STATE OF WASHINGTON DEPARTMENT OF ECOLOGY

July 19, 2004

Re: Quarterly Notification of Class 1 Modifications to the Hanford Facility Resource Conservation and Recovery Act (RCRA) Permit, Dangerous Waste Portion, (Quarter ending December 31, 2003-Permit Condition I.C.3)

Site Plan 242-A Evaporator

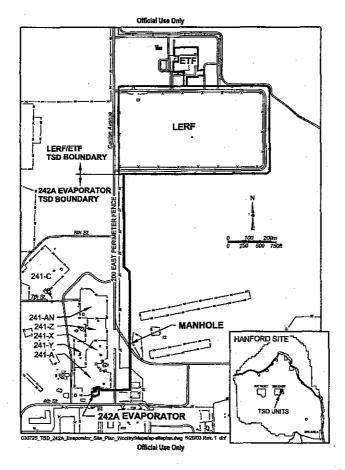
Chapter 1.0, Replace Figure: Replace Chapter 1.0 with the attached Chapter 1.0.

Figure 4.1. 242-A Evaporator Simplified Process Flow Diagram Added figure.

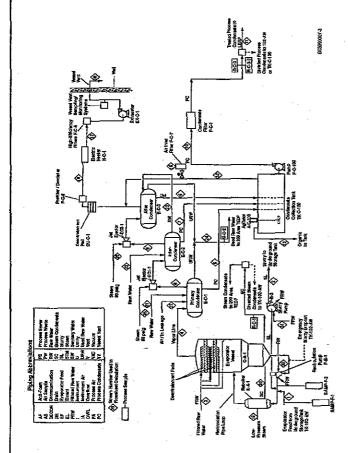
Figure 4.1: Approved

Chapter 4.0, Figure 4.1: Replace Chapter 4.0 with the attached Chapter 4.0.
